SECTION 4

FAILURES OF STATUTORY COMPLIANCE

4.1 Introduction

Figure 4.49: Extract from Studio E Employer's Requirements drawing 1279 (06) 110 00 'Proposed Typical Bay Plans, Section & Elevation' {SEA00002499}

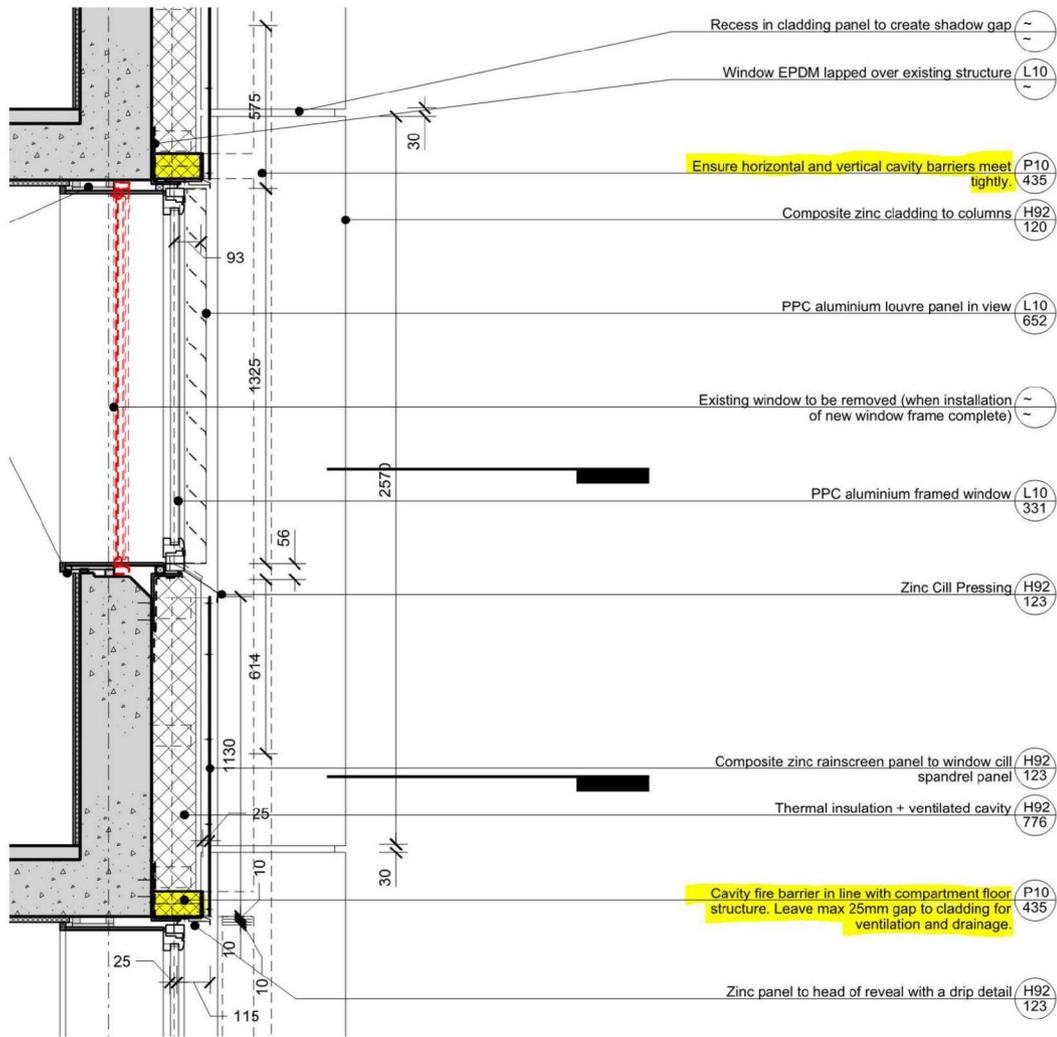
4.3.68 Studio E Employer's Requirements drawing 1279 (06) 110 00 '*Proposed Typical Bay Plans, Section & Elevation*' {SEA00002499} indicates, as shown below, cavity barriers to the line of compartment floor only. The cavity barrier at the window head (which carries no specification note) could possibly have functioned as both the barrier to inhibit the passage of fire into the cavity, and as the horizontal barrier that aligned with the compartment floor to inhibit the passage of fire through the cavity, if that had been agreed with the Consultant Specialist Fire Engineer (Exova) and the Building Control Officer. However, there is no cavity barrier indicated to the window sill. This was a very serious omission.

**Figure 4.50: Extract from Studio E Employer's Requirements drawing 1279 (06) 110 00
'Proposed Typical Bay Plans, Section & Elevation' {SEA00002499}**

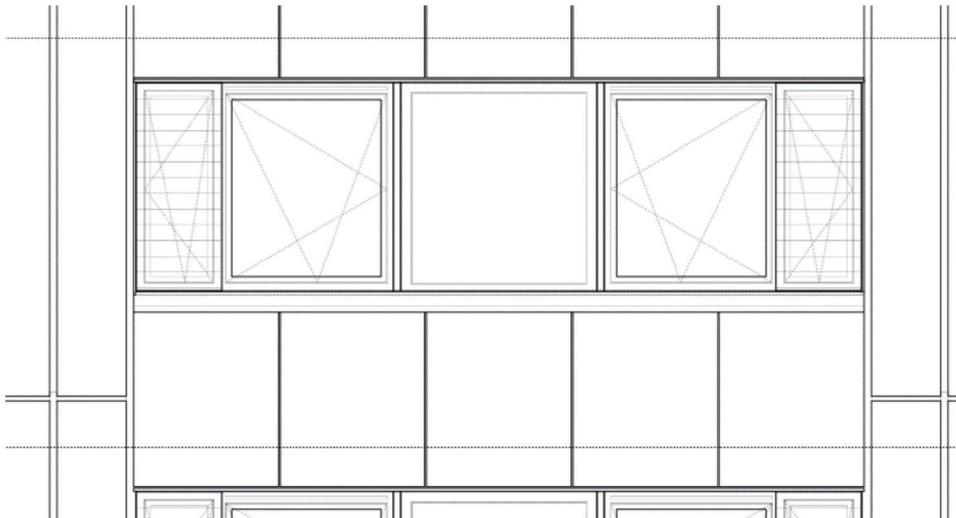
4.3.69 The same drawing 1279 (06) 110 00 {SEA00002499} also shows a typical bay elevation together with three plans and one section. No cavity barriers are shown to the bay elevation and no elevations of the complete facade are marked up to show cavity barriers (as shown within Section 3 of this report in relation to the indicative approach). This suggests that no clear thought had been given by Studio E in their preparation of tender documentation to the overall strategy in terms of 'compartmenting' or zoning the cavity behind the rainscreen.

Figure 4.51: Extract from Studio E Employer's Requirements drawing 1279 (06) 110 00 'Proposed Typical Bay Plans, Section & Elevation' {SEA00002499}

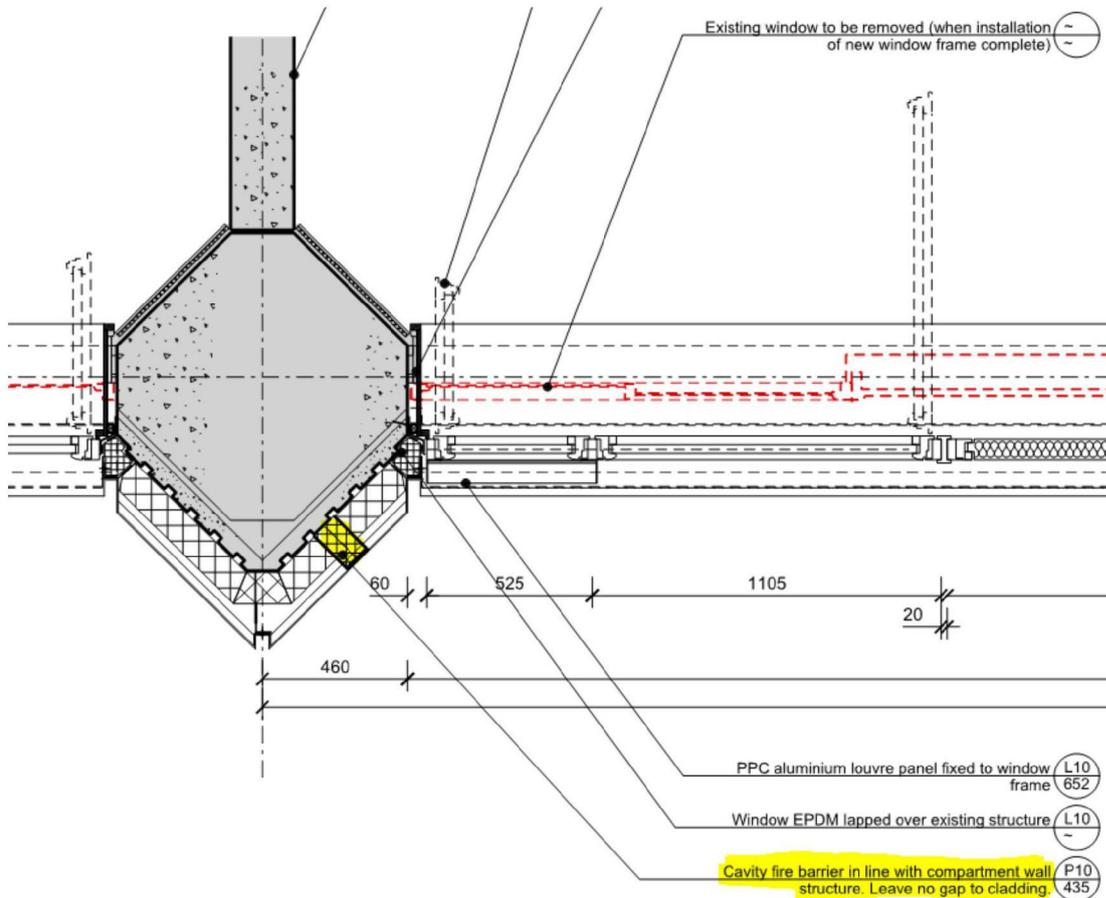
4.3.70 The same drawing 1279 (06) 110 00 {SEA00002499} also includes a typical 1:20 plan detail that references and shows a vertical cavity barrier along the line of a compartment wall in the area of a column. There is a suggestion of a change of material at the window jambs which appears to be coded with the same 'hatch' as the vertical cavity barrier, but the jamb components have no note or specification reference. This suggests that inadequate thought had been given to the window jamb conditions with respect to both fire stopping at the window frame /concrete column junction and inhibiting the passage of fire into the cavity at the window frame's edge condition.

Figure 4.52: Extract from Studio E drawing 1279 (04) 105 'Proposed Residential Plan' {SEA00010474}

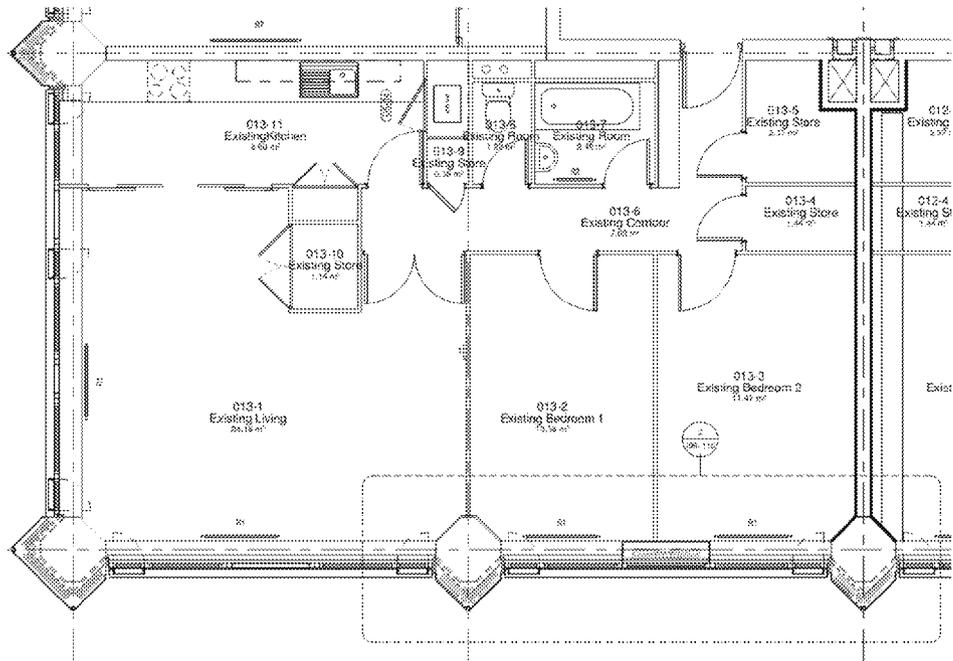
4.3.71 Studio E Tender drawing 1279 (04) 105 00 {SEA00010474} entitled 'Proposed Residential Plan' dated 9 November 2013 shows, at 1:50 scale, the cladding arrangement and typical bay reference. There is no indication on that drawing of the positioning of cavity barriers that are required at compartment wall/column junctions: that is at columns A3/B1/B5/C1/C5 and D3. Whilst this is not strictly necessary on the 1:50 plans, as the 1:20 column plan shown above clearly indicates vertical cavity barriers are required at all 'compartment column' positions, it is my opinion that this again indicates a lack of care and attention in terms of the development of a strategy in relation to the positioning of cavity barriers.

4.3.72 An architect acting with due diligence and care would, in my view, show all vertical and horizontal cavity barriers carefully at an appropriate scale for all four complete façade elevations, then at 1:20 scale for all bay and all column conditions, then at 1:5 scale for details at head, sill column at window level and column at spandrel panel level, as demonstrated in Section 3 indicative scheme.

Figure 4.59: Extract from Studio E drawing 1279 (06) 120 00 'Detailed Section - Sheet 1' {SEA00002551}

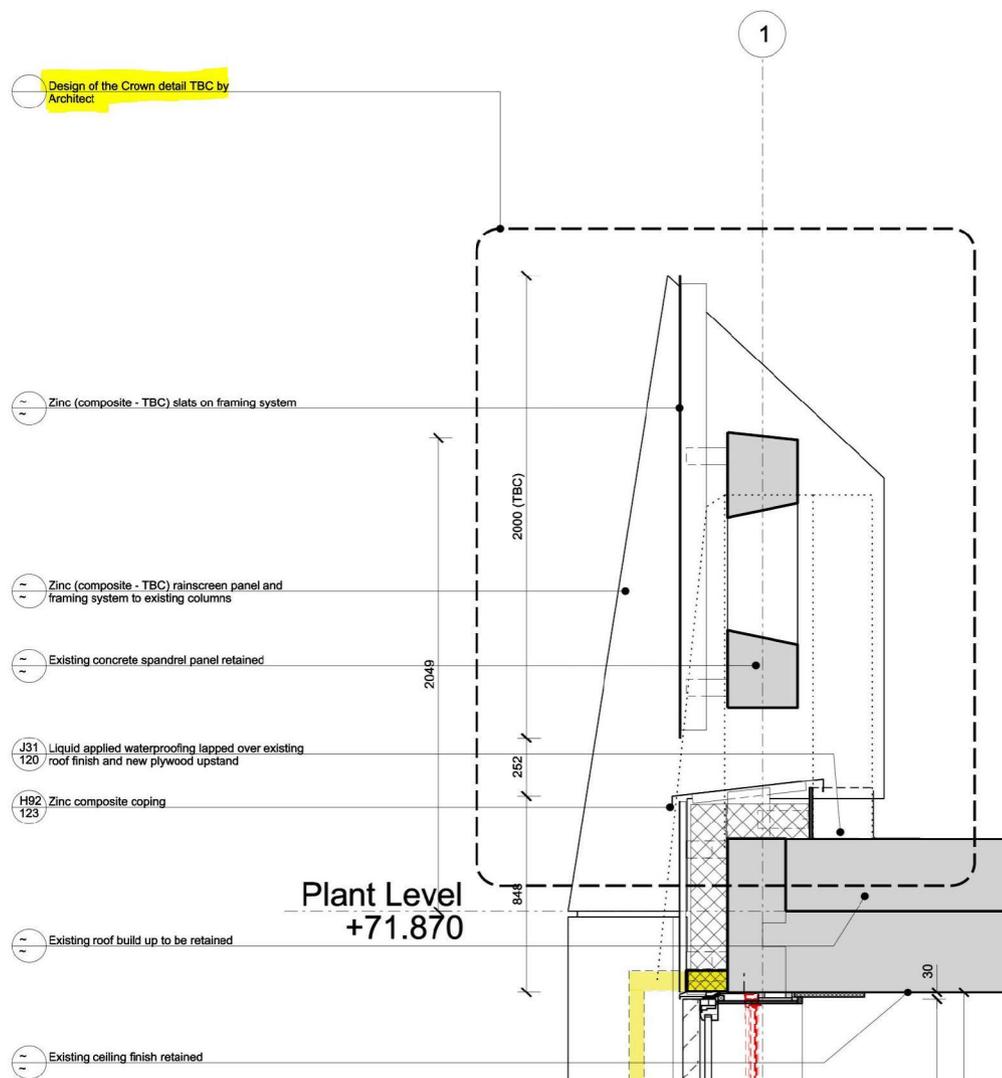
4.3.81 With respect to the Crown Studio E seem to have provided little in the way of information at Tender Stage. However, the following exhibit provides some (albeit scant) indication of intent. There are no elevations to show the overall strategy for achieving compliance with the guidance in ADB2. The section implies that although the horizontal cavity barrier to the window head runs horizontally onto the column face to connect with a vertical cavity barrier, that is not shown on the 1:50 general arrangement plans, and there is no horizontal barrier indicated to close either the top of columns or the parapet at roof level. This information is, in my opinion, inadequate and insufficiently thought through. I do note that the drawing states that the 'design of the Crown detail TBC by Architect' – i.e. that it is to be confirmed by the architect at a later stage. Whilst this is arguably sufficient for tender purposes, it leaves an unresolved area which Studio E appear never again to have addressed.

Figure 4.61: Extract of 'Proposed Plan at Window Level' from drawing 1279 (06) 110 00 'Proposed Typical Bay, Plans, Section & Elevation' {SEA00002499}

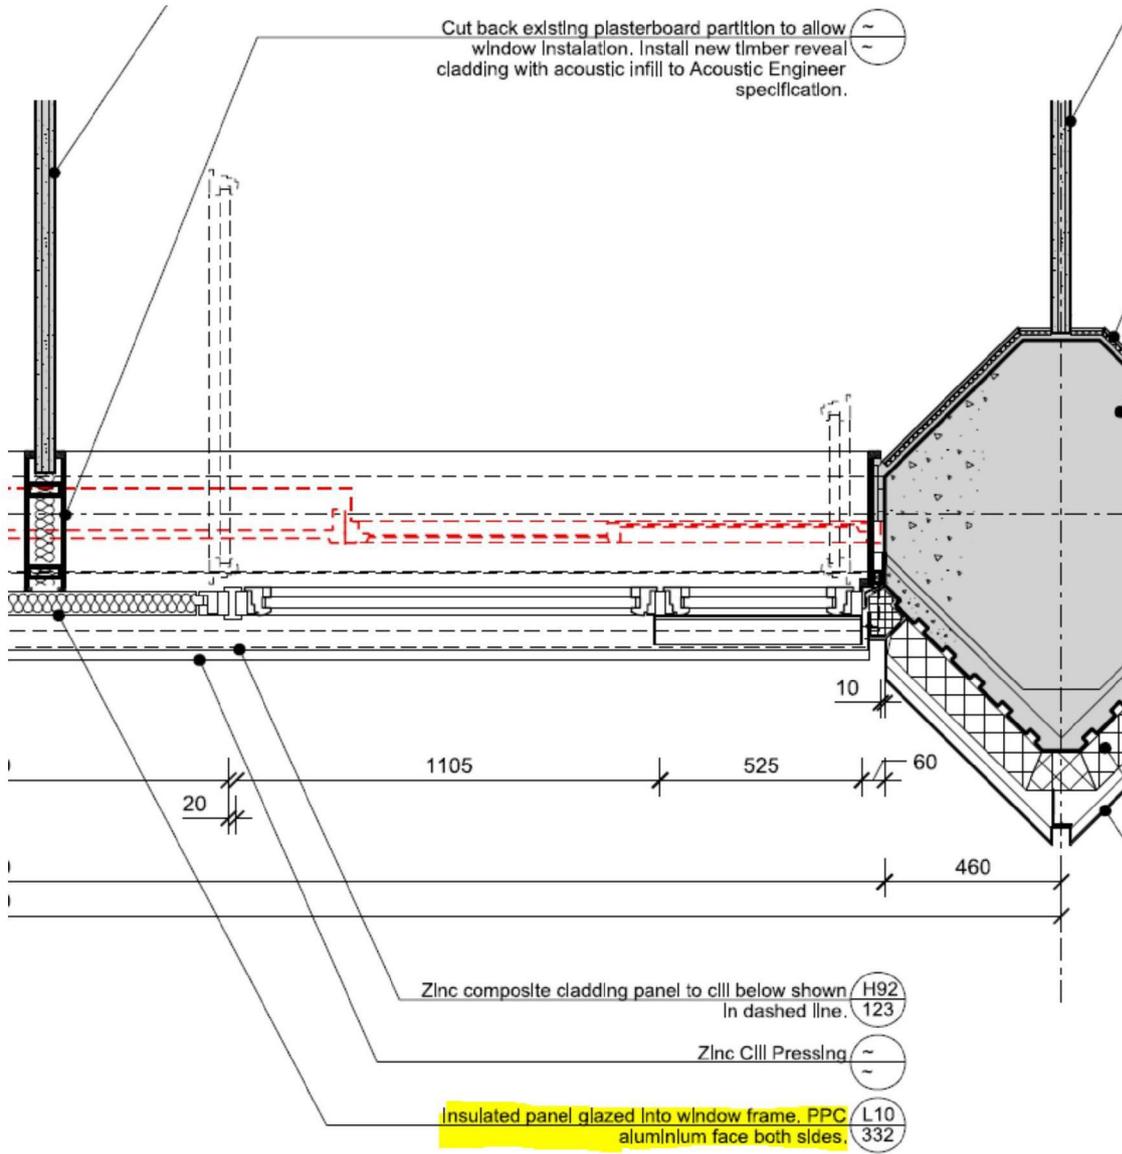
4.3.90 Studio E Employer's Requirements drawing 1279 (06) 110 00 'Proposed Typical Bay Plans, Section & Elevation' {SEA00002499} includes a typical 1:20 plan detail that references the insulated panel between windows. However, there is no product or insulation type reference. The specification reference that is included does not identify the core material and only states the external and internal face finishes.

Figure 4.64: Extract of ‘Proposed Section – Typical Bay’ from drawing 1279 (06) 110 00 ‘Proposed Typical Bay, Plans, Section & Elevation’ {SEA00002499}

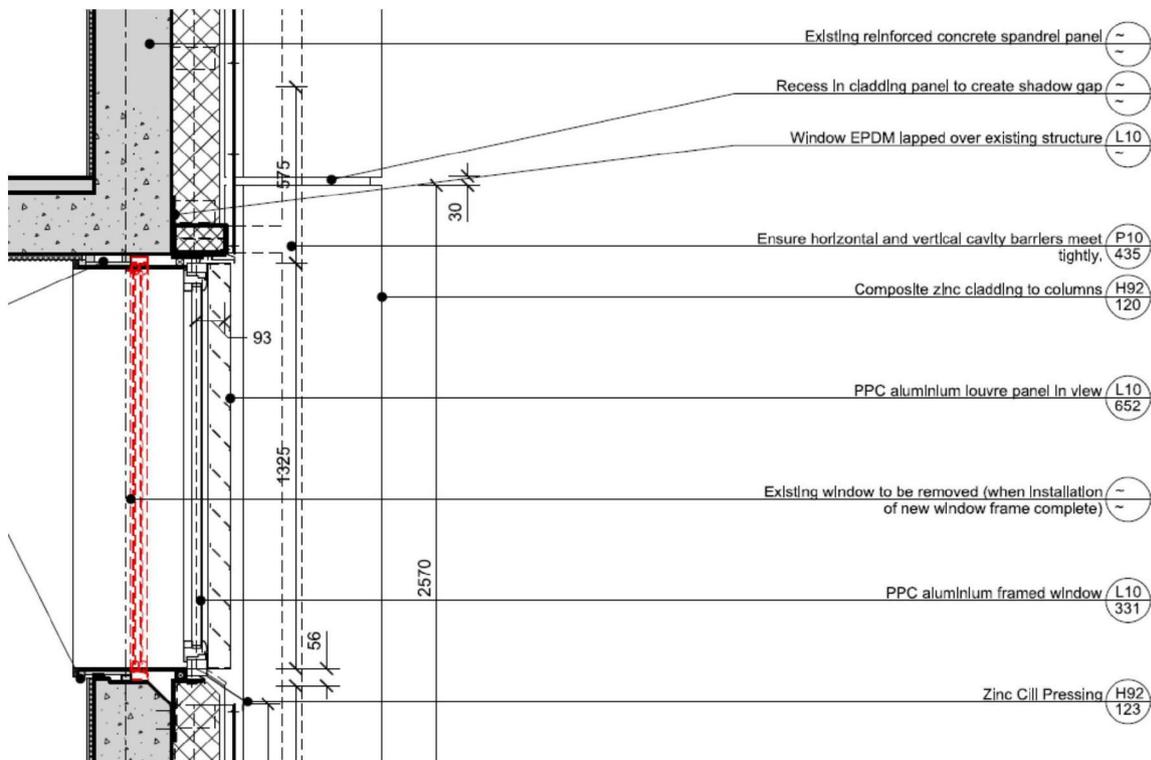
4.3.95 Studio E Employer's Requirements drawing 1279 (06) 110 00 ‘Proposed Typical Bay Plans, Section & Elevation’ indicates a typical 1:20 section through the window opening. However, there is no indication of any packing material to the internal window lining to reduce the thermal bridging at either the head or sill interface. {SEA00002499}. As stated under Section 3 this is necessary in order to maintain the continuity of the new thermal insulation and avoid situations of ‘cold bridging’. (This occurs when the insulation is interrupted, or its performance is compromised and can lead to condensation, mould and damage to decorations).

Figure 4.78: Mark up of Harley Elevation C1059-201-D {HAR00008886}

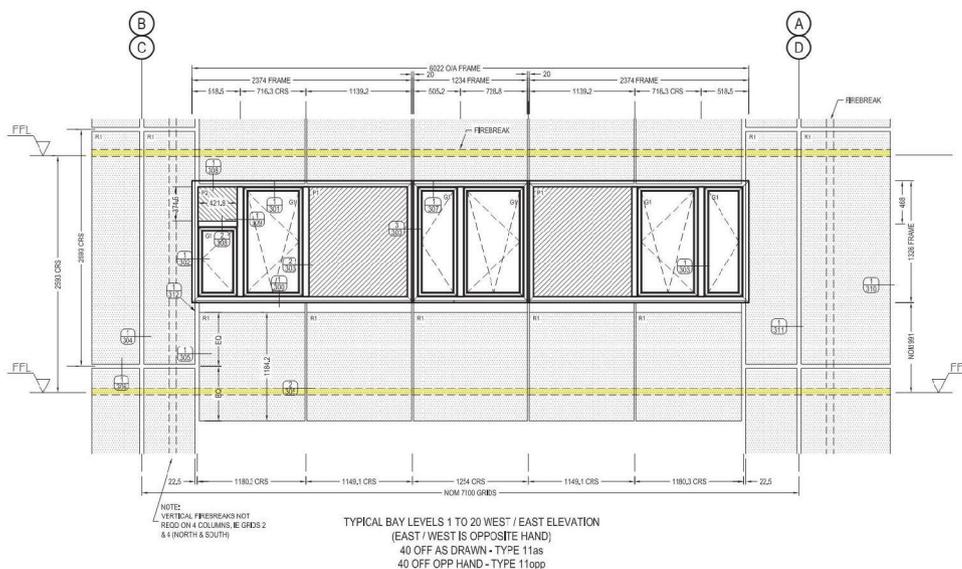
4.4.99 As shown in the exhibit below the horizontal 'Firebreaks' that are indicated on the elevations are not shown within the depth of the compartment floor as they are projecting (in part at least) above the FFL (finished floor level) dashed line. I have marked up the exhibit to show this clearly. These should align with the compartment floors, that is, they should be set to fit entirely between the underside of the concrete floor and its topside, albeit within the cavity in order to comply with ADB2 Diagram 33. But they do not so align and therefore do not comply with that guidance. That stated, I do not believe anything material turns on this as the spandrel panel is effectively a continuation of the concrete slab and therefore may simply be considered as an extension to the thickness of the slab at its edge. I do however believe that Harley/Studio E should have cleared such positioning with Building Control.

Figure 4.79: Extract of Studio E 'Proposed Plan at Window Level' from drawing 1279 (06) 110 - 00 {SEA00002499}

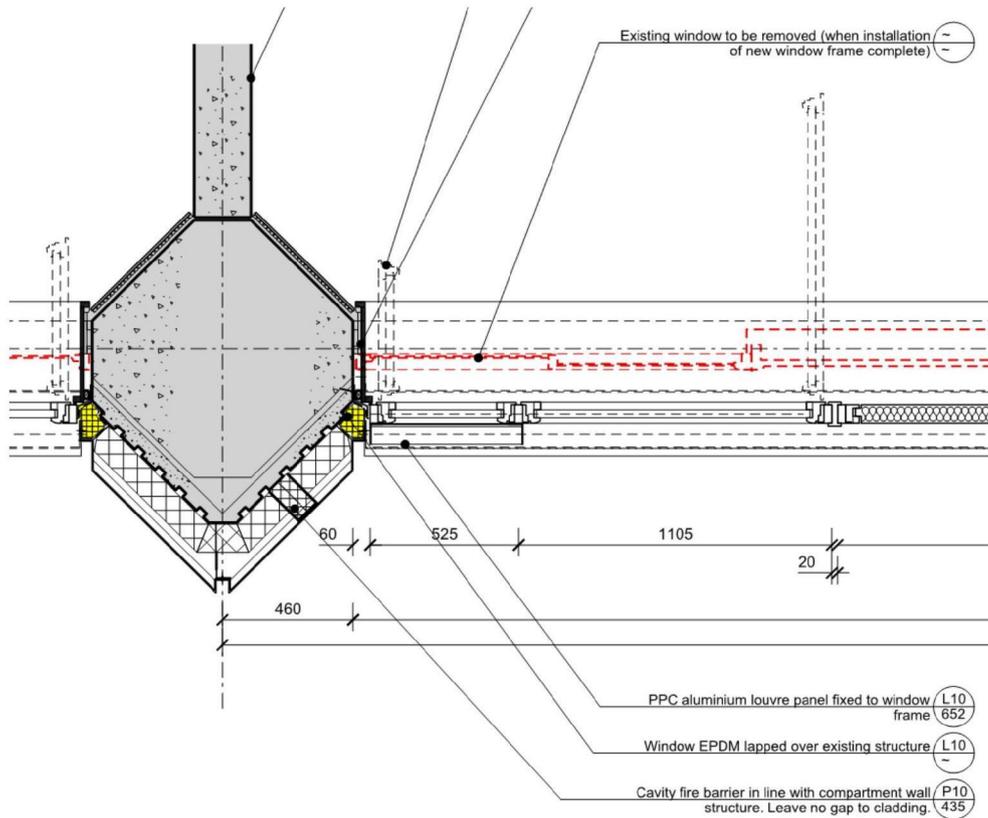
4.4.101 There is no reference on the three Harley typical bay drawings to any cavity barriers around the window openings. I have shown within the indicative approach under Section 3 where these should be located (for example at Figure 3.16). This omission on the part of both Harley and Studio E represents a fundamental failure to comply with the guidance in ADB2. It also represents a serious worsening of the non-ADB2 compliant arrangements shown within the Studio E tender information, whereby although there was no proper reference to cavity barriers at the jambs there was at least an indication of possible intent in that respect. The exhibit below shows this clearly highlighted.

Figure 4.83: 'Open State' Cavity Barrier Highlighted in Yellow on Harley Detail C1059-301-E {HAR00003958}

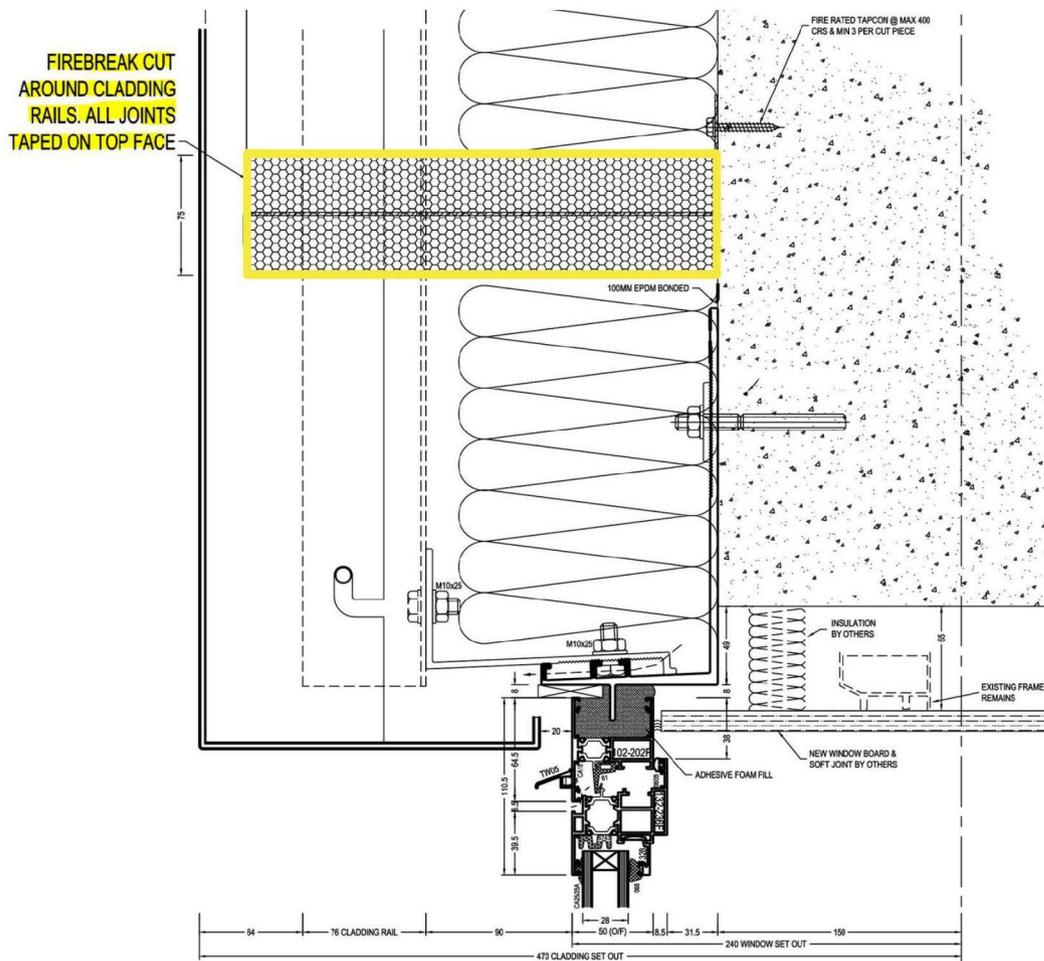
4.4.106 Harley Detail C1059-301-E {HAR00003958} which is a detail section at the window head indicates (as shown in Figure 4.83 below) that the Open State Cavity barrier is mechanically fixed back to the structure. The detail indicates the SideRise product with the RH25 reference (see highlight on exhibit), which is designed for air gaps up to 25mm +/-3mm between outer face of the barrier and the back of the cladding. Its outer edge comprises an intumescent strip. The barrier therefore extends into the cladding cassette (as shown) in order to provide and maintain a maximum air gap of 25mm. It is not clear how the integrity of the barrier is maintained as the cavity barrier is expressly noted as being 'cut around cladding rail'.
